Service Info

Change of design to protective dust cover

Part replacement - RIU: 566283.H195 replaced with 566283.01.H195

Image 1: The design of the dust-protection cover has been changed

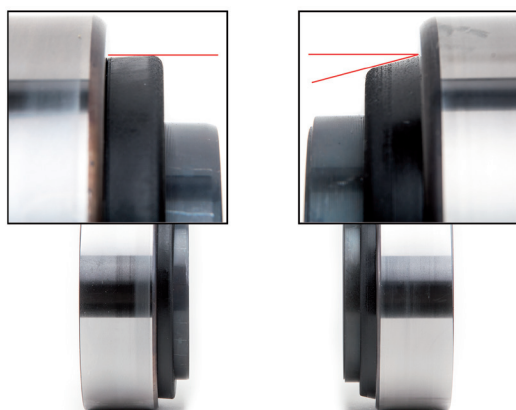
During fitment of Repair Insert Unit (RIU) part number 566283.H195, the protective dust cover may become twisted on some wheel hubs. In the worst case scenario, a twisted protective dust cover may cause a bearing to become obstructed, thereby making it difficult for the wheel hub to turn or prevent it from turning altogether.

For this reason, a modified protective dust cover has been developed (see image 1).

As a result of this technical modification, part number 566283.H195 has been replaced with 566283.01.H195.
